DOOSAN Document Transmittal Upper Trishuli-1 HEP (216MW)	Date 2022-03-06	DT No.: UT1-HEP-DHI-PC-D-0009	SHEET 1 OF 1
DOOSAN NEPAL BRANCH OFFICE	Address & Contact No. : Four Square Building, Naxal, Kathmandu, Nepal (P.O Box : 1387) + 977 1 692 3014	Project No. H20002	DOCUMENT DISPATCHED BY Courier Service ☐ Messenger ☐ Post-Air Freight ☐ Document System or E-mail ■ By hand ■
DOCUMENT DISTRIBUTION	■ POWER CHINA (Subcontractor) ☐ Doosan's Site Office		
SUBJECT	Review Note RN-0075_Layout Drawing of Flushing Tunnel

UPPER TRISHULI-1 HEP (216MW)

REVIEW NOTE

Contractor	**Doosan Heavy Industries & Construction Co., Ltd.**		
Title of the Document	Layout drawing of flushing tunnel, sheets 1-3		
Document No.	UT1-C-030-CVL-DG-53001	Revision	0A
Date of Documents	28.07.2021	Received Date	19.08.2021
Transmittal Form No.	UT1-HEP-DHI-D-0031		
Previous Review Date/Status	N/A	Prev. Review Note No.	N/A
Review Note No.	**RN-0075**	**Present Review Date**	**05.03.2022**
		Present Review Status	**RR**

DRAWING TITLE: LAYOUT DRAWING OF FLUSHING TUNNEL (1/3)

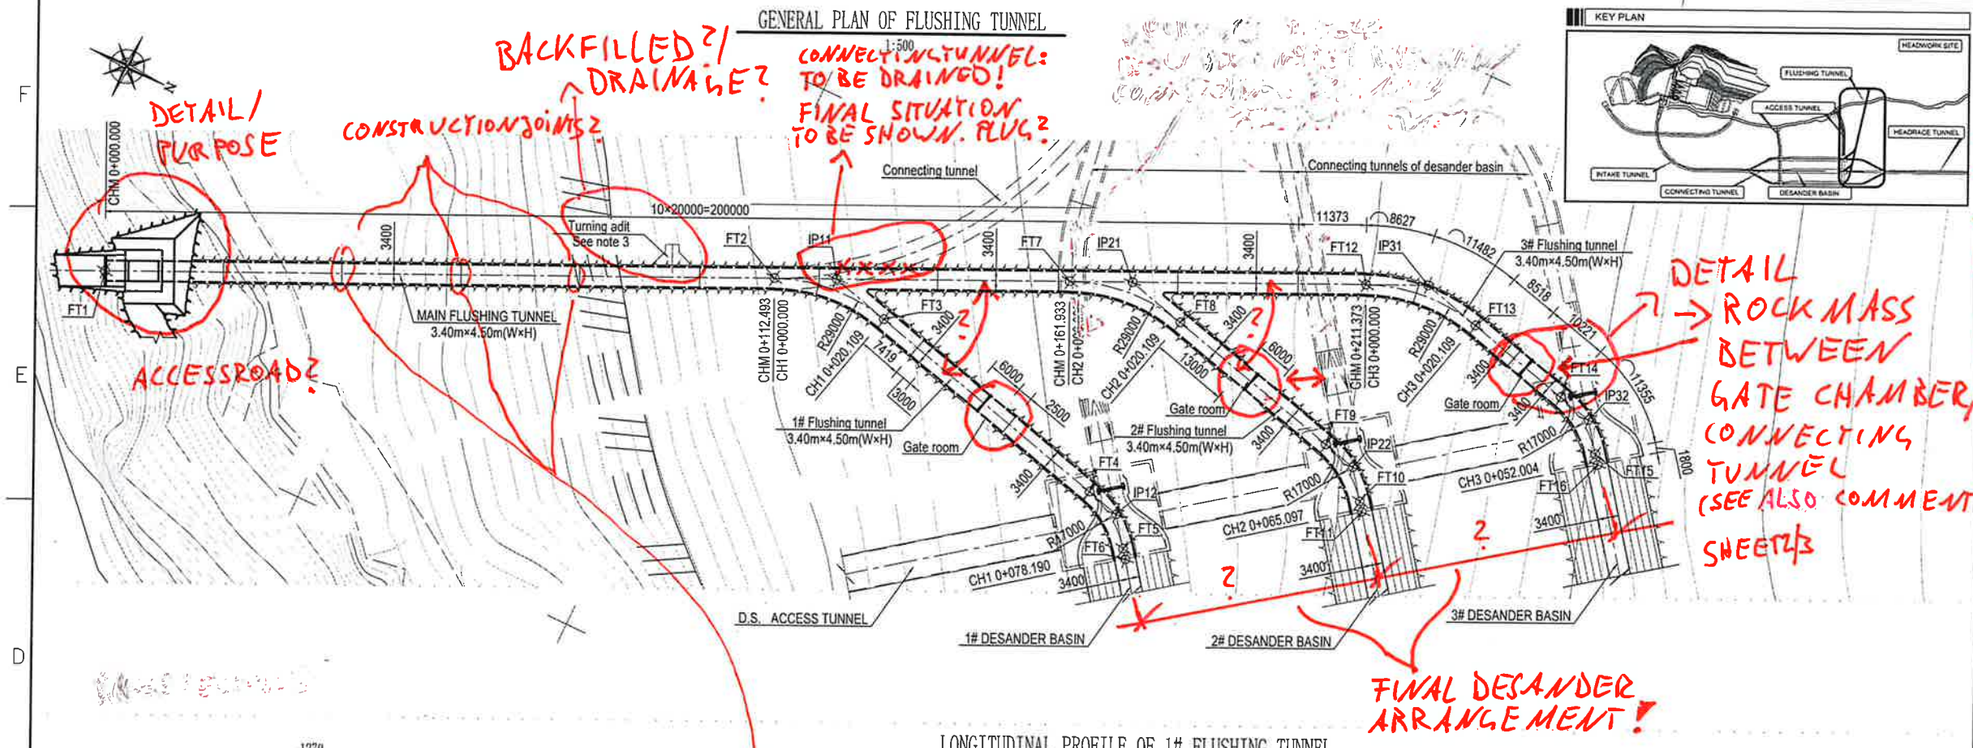
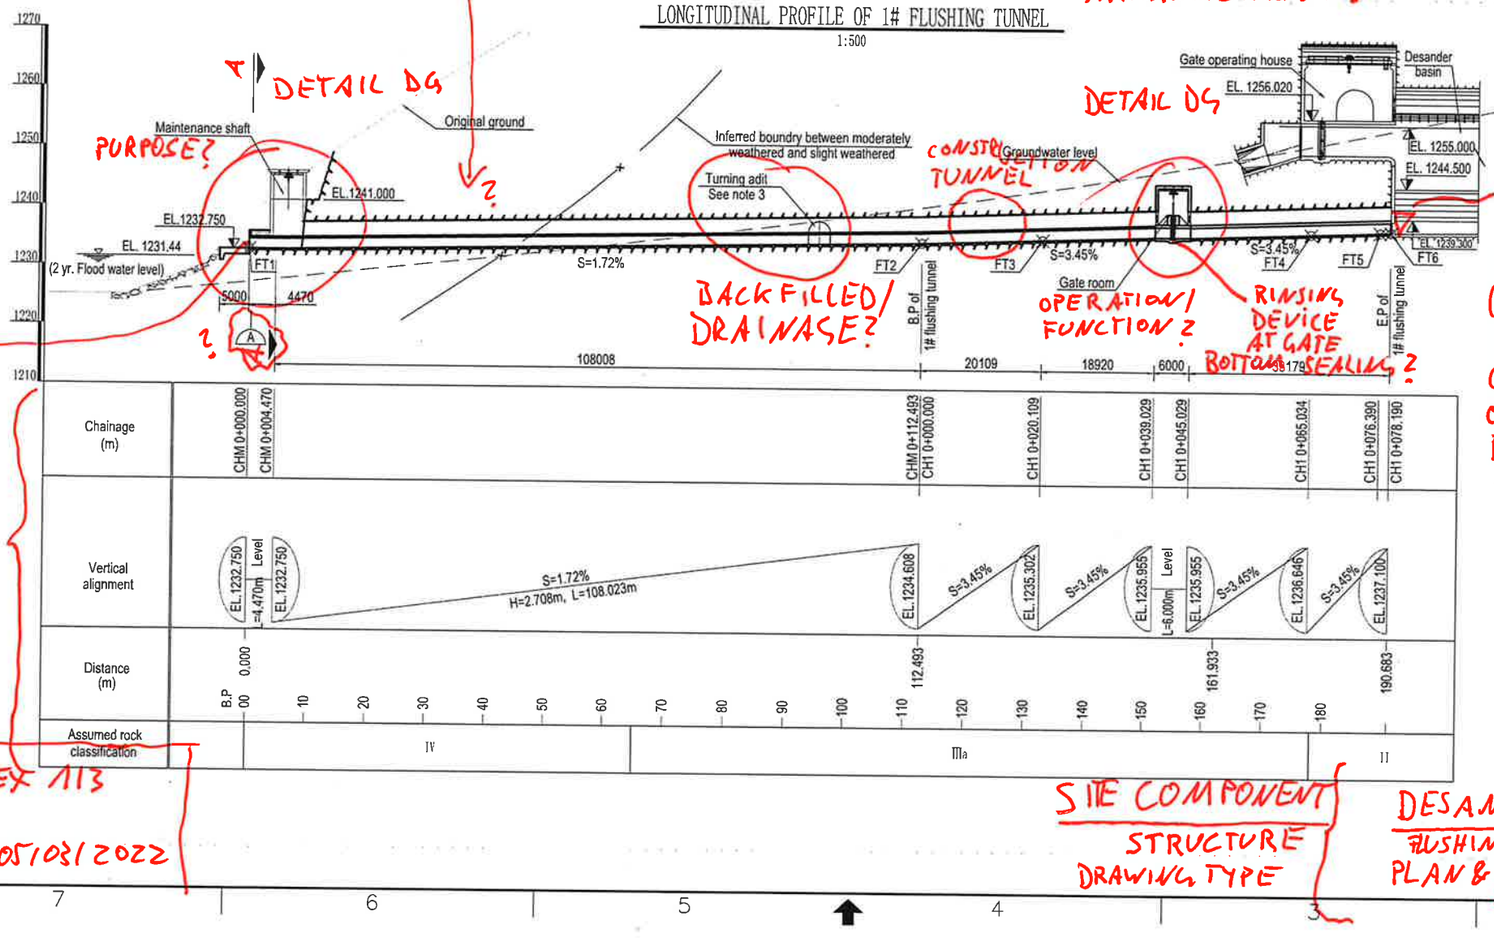
BACKFILLED? / DRAINAGE?

CONNECTING TUNNEL: TO BE DRAINED! FINAL SITUATION TO BE SHOWN. PLUG?

CONSTRUCTION JOINTS?

DETAIL / PURPOSE

ACCESSROAD?

DETAIL → ROCK MASS BETWEEN GATE CHAMBER / CONNECTING TUNNEL (SEE ALSO COMMENT SHEET 3)

FINAL DESANDER ARRANGEMENT!

DETAIL DG

PURPOSE?

CONSTRUCTION TUNNEL

BACKFILLED / DRAINAGE?

OPERATION / FUNCTION?

RINSING DEVICE AT GATE BOTTOM SEALING?

ELEVATION TO BE CONFIRMED (SLOPE OF FLUSHING CHANNEL OF DESANDER BASIN → RN-0018)

CLOSED WITH GRID?

SEE EXAMPLE PROTOTYPE DG

DETAIL DESIGN REPORT & CALCULATIONS?

DRAWING TITLE: LAYOUT DRAWING OF FLUSHING TUNNEL (2/3)

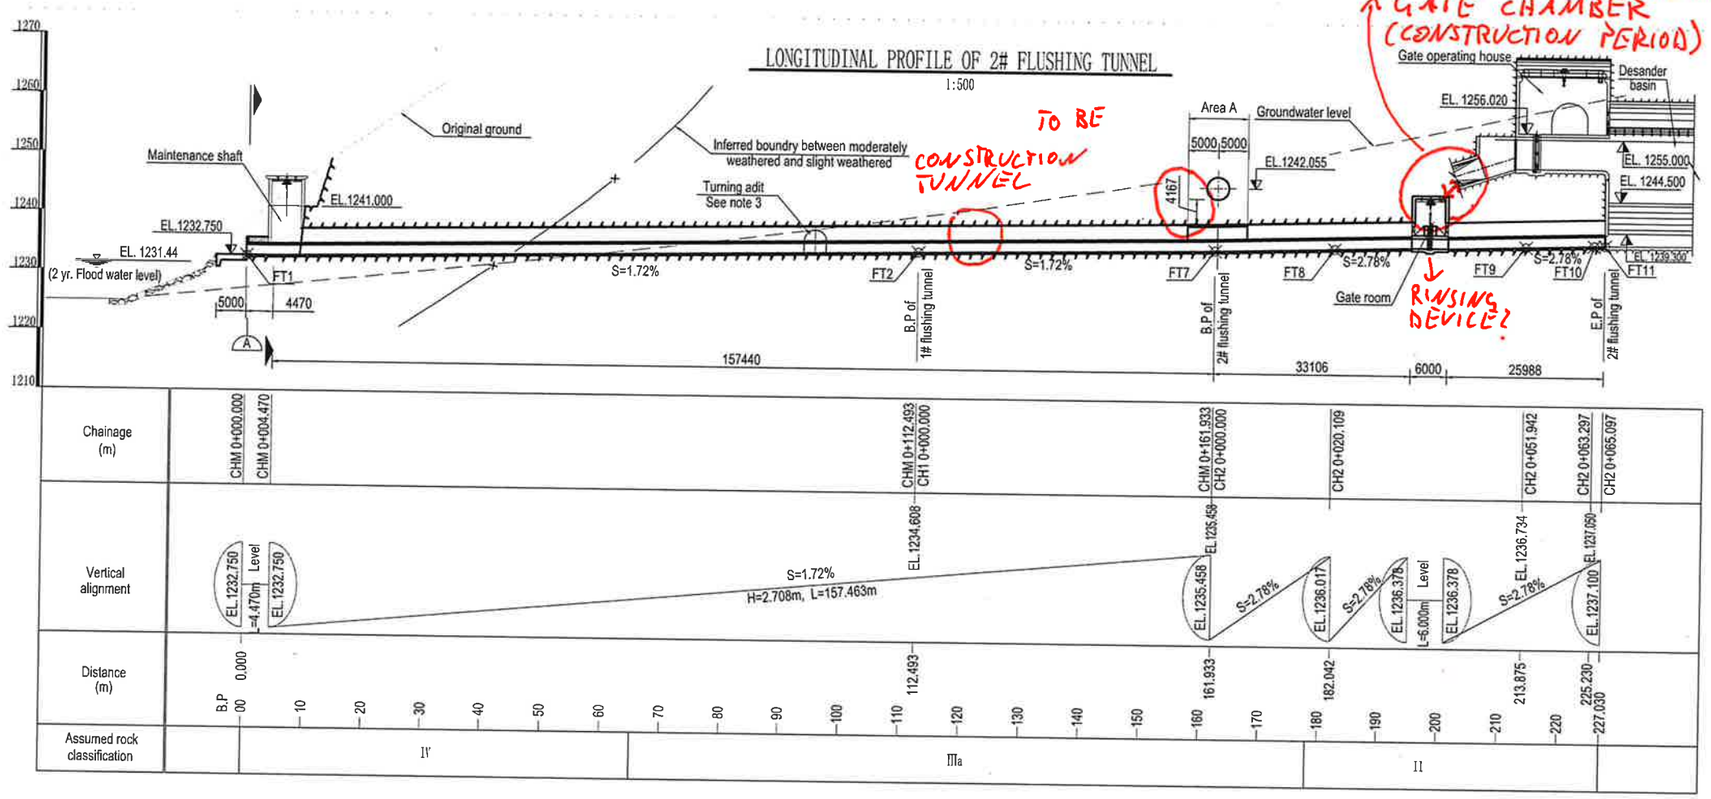
SEE ALSO COMMENTS OF SHEET 1

LAYOUT DRAWING OF FLUSHING TUNNEL (3/3)

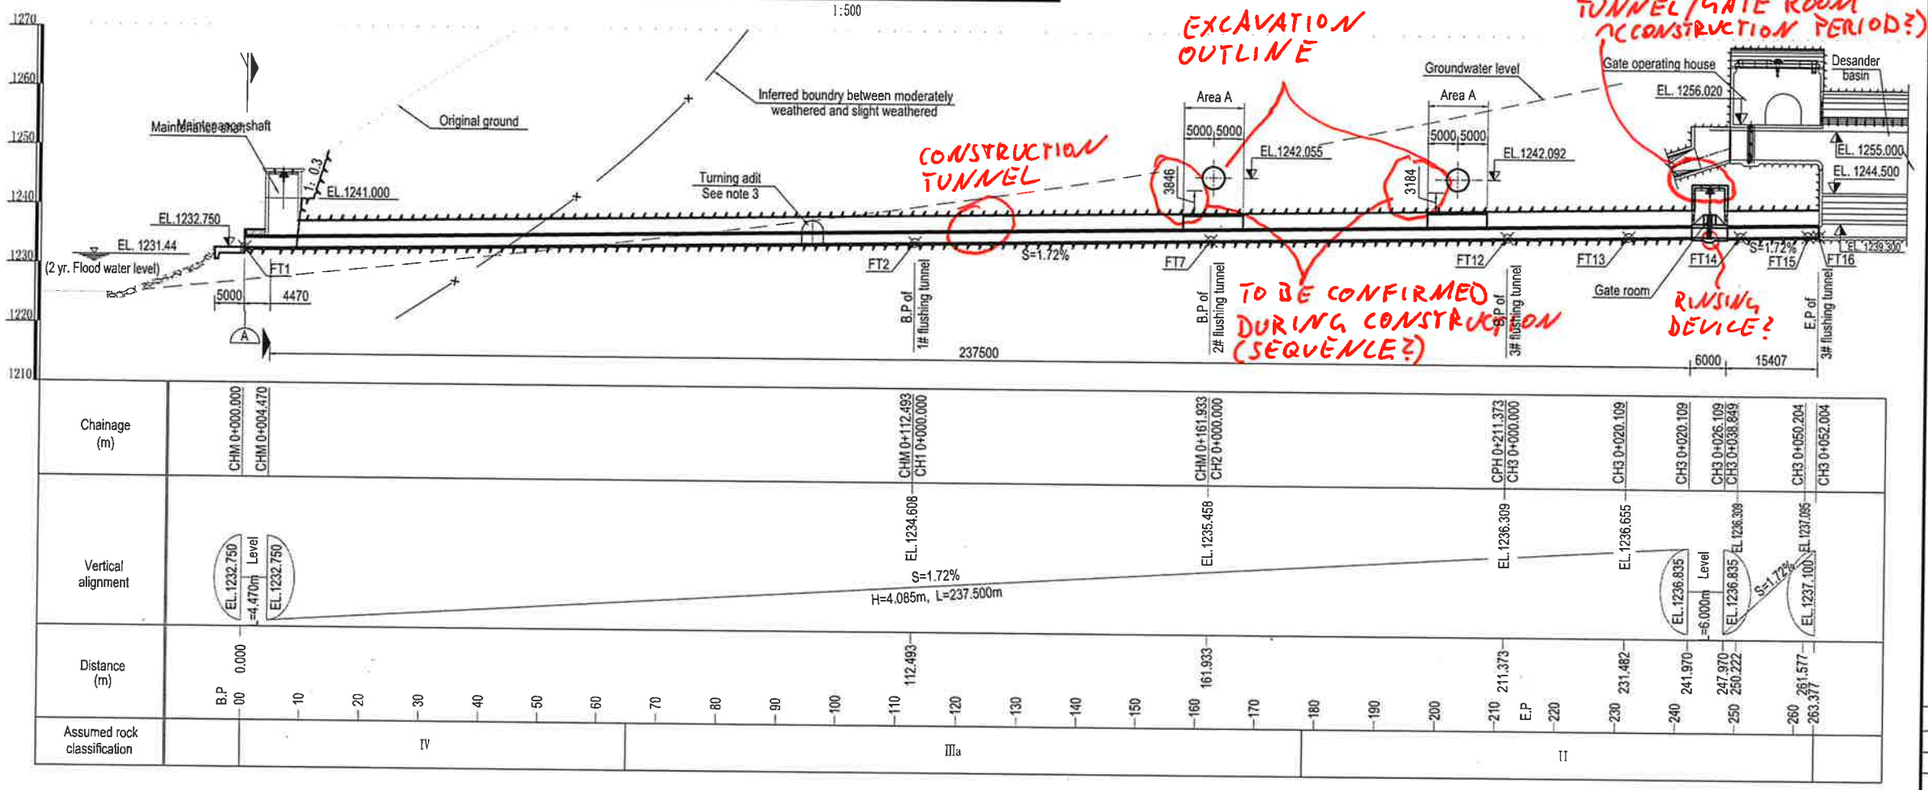
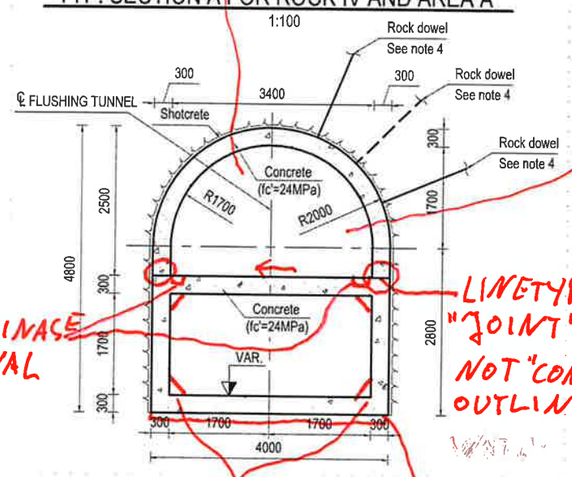
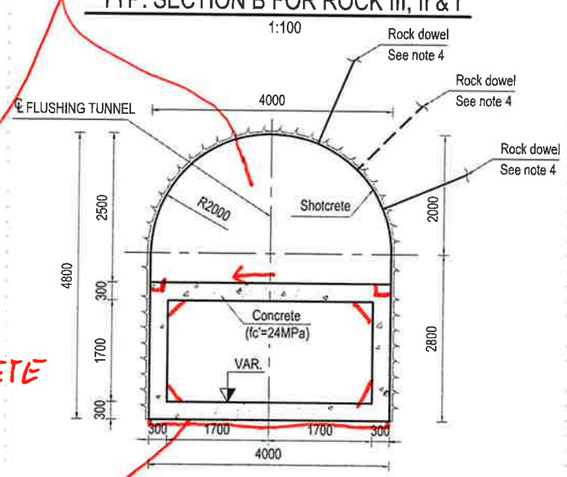
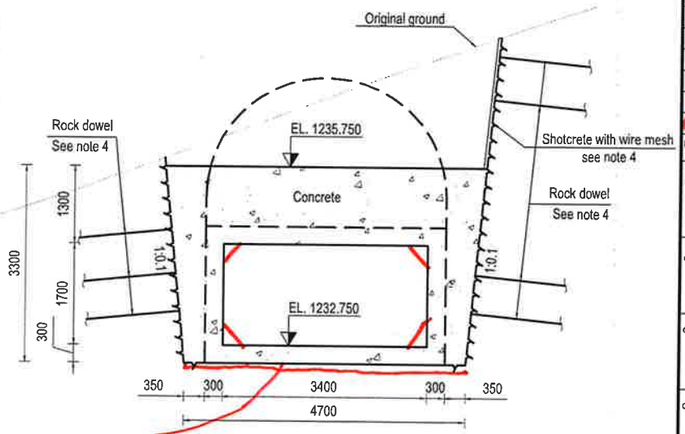
CLEARANCE SUFFICIANT? (TRANSPORTATION OF EQUIPMENT E.G. GATE?) MAINTENANCE DURING OPERATION

WALKWAY? SUPPLY FACILITIES?

DRAINAGE CANAL

LINETYPE "JOINT", NOT "CONCRETE OUTLINE"

CHAMFERS FAVORABLE

LEAN CONCRETE

SEE ALSO COMMENTS OF SHEET 1
